**INFO-TECH CITROËN Sport C2 R2 MAX N° 04/08.**

Subject : Alternator, reliability modifications.

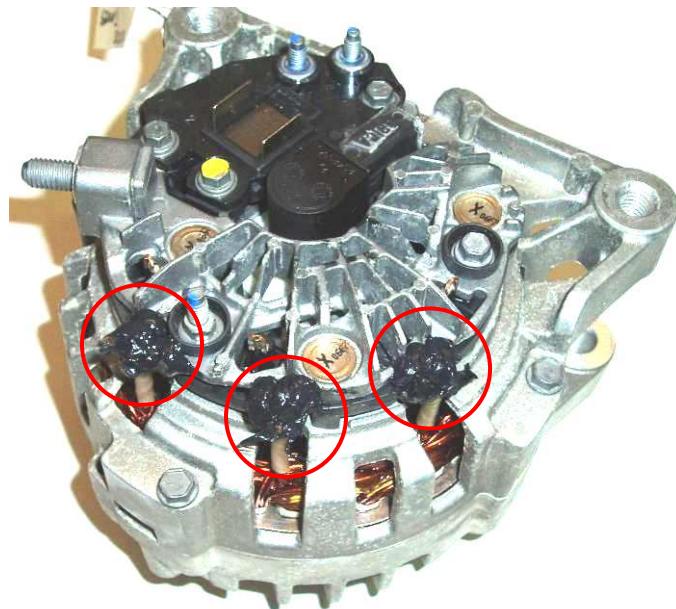
1 - Remove the plastic bonnet, by unscrewing the 3 nuts shown on the picture below :

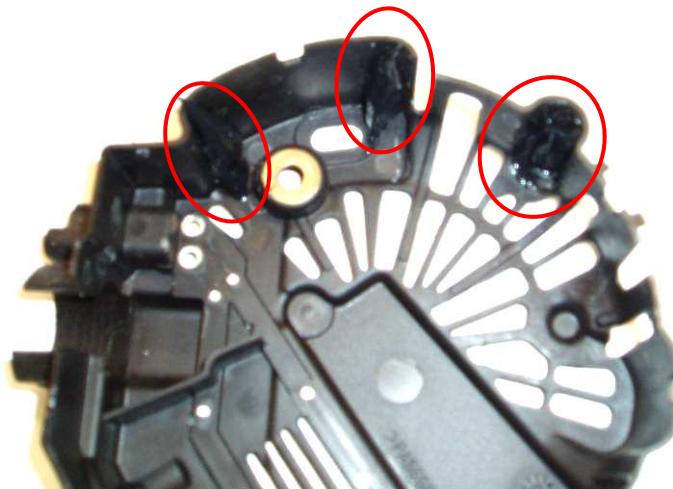
2 - Apply some seal paste (« caf ») on 3 poles shown on the picture below and the body as well, to reduce vibrations :

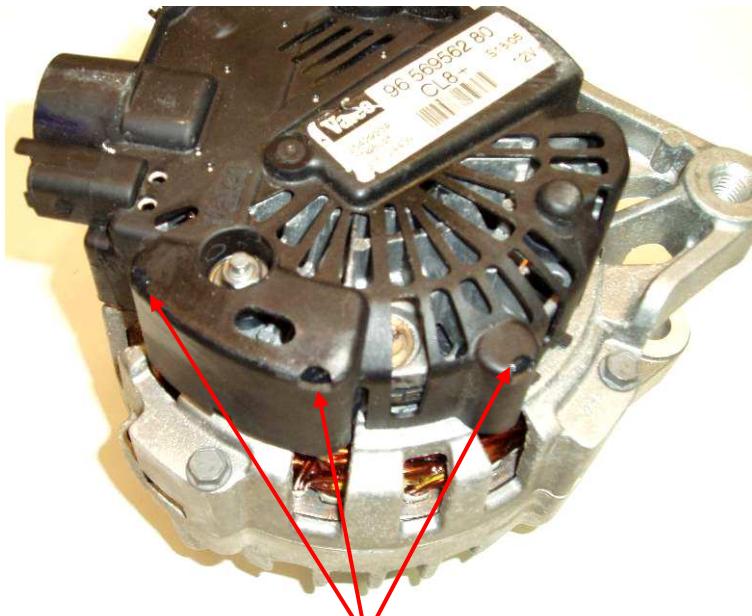
3 - Apply generously some seal paste (« caf ») on pole areas inside the bonnet, as shown on the picture below :

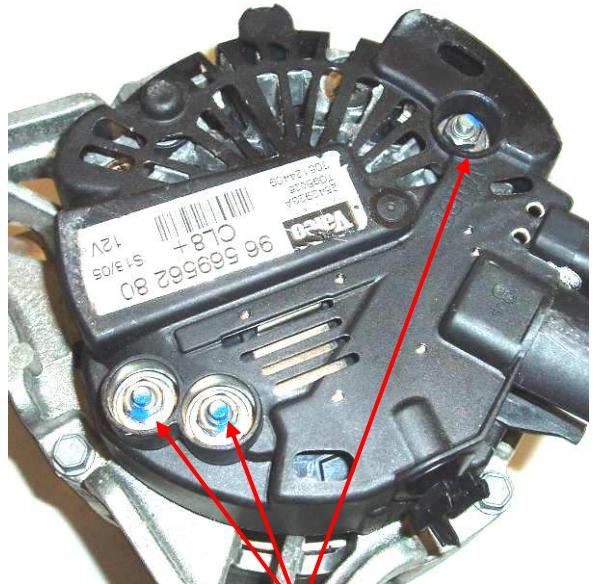
4 - Cover the alternator with his bonnet and torque the three nuts :

The paste, with the right quantity,  
must appear on each window.

Torque : 0.8 m.kg  
+ paint marks
